Franklin County Board of Zoning Appeals

Monday, November 17, 2014
1:30 p.m.

STAFF REPORT

Case VA-3826

3 FRONT ELEVATION
1/8" = 1'-0"

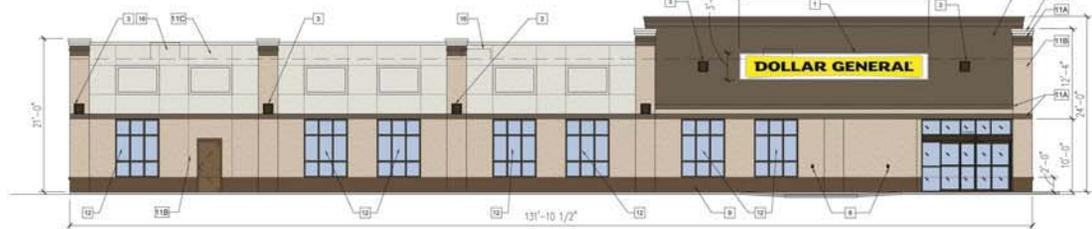
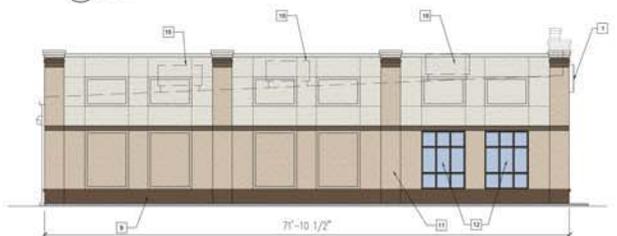
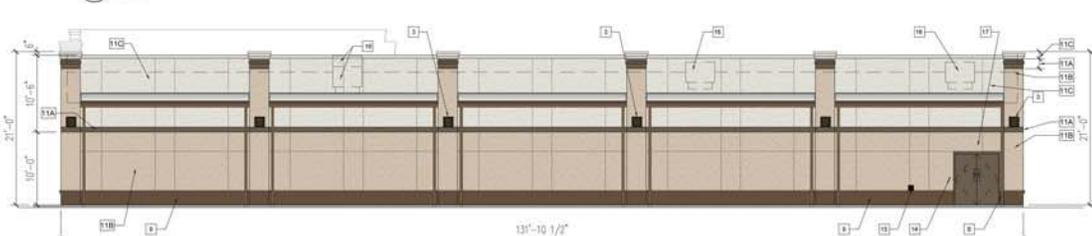
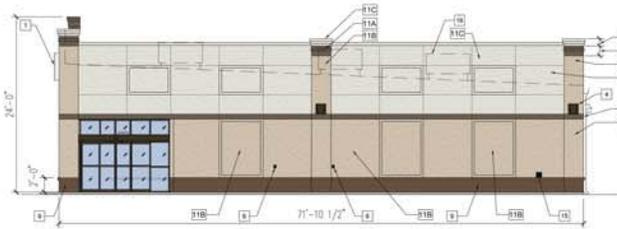
Variance from Section 670.083(h(4)) – Building Façade (Window Glass):

- Clear window glass that permits a full, unobstructed view of the interior to a minimum 4 foot depth shall be used when adhering to the building façade requirements.
 - The proposed windows use “spandrel glazing” that do not provide any view of the interior.

- Building Façade (Window Glass) - 670.083(h(4))
 - Applicant states that a literal interpretation causes inefficient interior layout effectively reducing the amount of products that can be sold.
 - Staff notes that a literal interpretation does not deprive the applicant of any rights to use the property as compared to other properties in the same zoning district. The interior function of the building is a limitation imposed by the applicant and not the property.

- Building Façade (Window Glass) - 670.083(h(4))
 - The applicant states that this will not confer a special privilege as other retail establishments would need the same spandrel glazed glass to effectively store merchandise.

- Based on staff analysis, this will confer a special privilege as other retail establishments need to adhere to the requirement regardless of their preferred interior operations and storage.

- Building Façade (Window Glass) - 670.083(h(4))
 - Based on staff analysis, spandrel glazed windows creates a façade that is uncharacteristic of the Smart Growth Overlay and incompatible with future development that meets the overlay requirements.

Staff recommendation is that the BZA *deny* a Variance from Sections 670.083(b), 670.083(g), 670.083(h(4)), 501.012, 505.022(a), and 531.032 of the Franklin County Zoning Resolution to allow the development of a retail store that will fail to meet the maximum building setback, building entrance location, facade, fence height, dumpster location, loading space location and loading space setback requirements. The reasons for denial are:
